SOUTH YORKSHIRE MINING ADVISORY SERVICE

**BUILDING REGULATIONS 2000
APPROVED DOCUMENT A - STRUCTURE (2004 EDITION)
REQUIREMENT A2(b) - SUBSIDENCE**

Application No: 16/07712/BR

Description: PAIR OF SEMI DETACHED PROPERTIES

**BUILDING REGULATIONS 2000
APPROVED DOCUMENT A - STRUCTURE (2004 EDITION)
REQUIREMENT A2(b) - SUBSIDENCE**

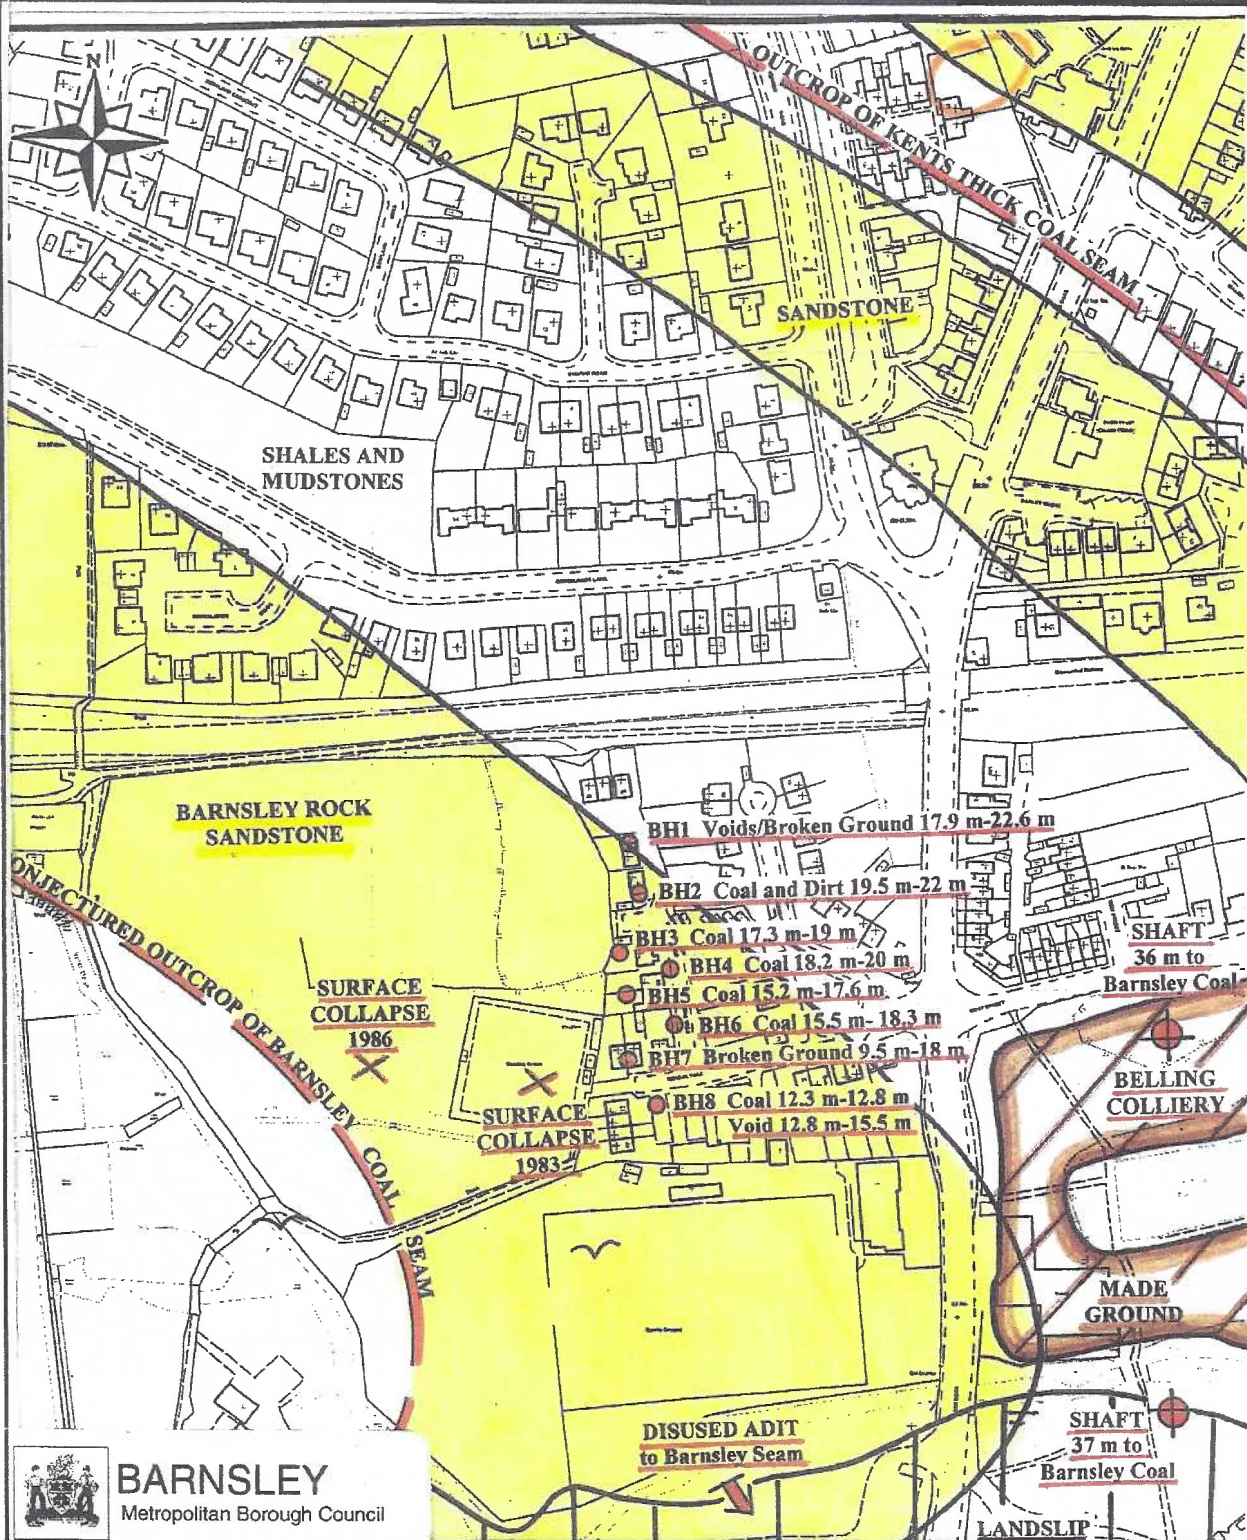
There is insufficient surface information on the site plan for a report to be completed.	A1
This site is fully covered by the attached report no.	A2
The conjectured surface position of geological faulting crosses the area as shown on the attached plan.	A3
Fissure problems may be encountered in the underlying sandstone bedrock.	A4
The conjectured outcrop of the coal seam marked on the attached plan may be exposed in the foundations.	A5
The coal seam shown on the plan may be under the proposed development at a shallow depth.	A6 ✓
Shallow mineworkings in the coal seam marked on the attached plan may be present under the site.	A7 ✓
The mine shafts marked on the attached plan are recorded adjacent to the site boundary.	A8
The area marked on the attached plan is shown to be made ground.	A9
The site will be affected by current/future mining.	A10

The foundations may have to be suitably designed as advised by a structural engineer to minimize the effect of historic shallow mine workings. SYMAS has no records regarding existing foundation design.	B6
The nature and suitability of any made ground should be investigated, foundations should be suitably designed	B7
Precautions may be required should development be located over the highwall of the former opencast/quarry site due to the potential for differential settlement occurring.	B8
Although it is not a consideration of the A2(b) requirement all the usual safety precautions and monitoring procedures in respect of fugitive gases (associated with shallow coals, mine entries, made ground or landfill) should be employed.	B9 ✓
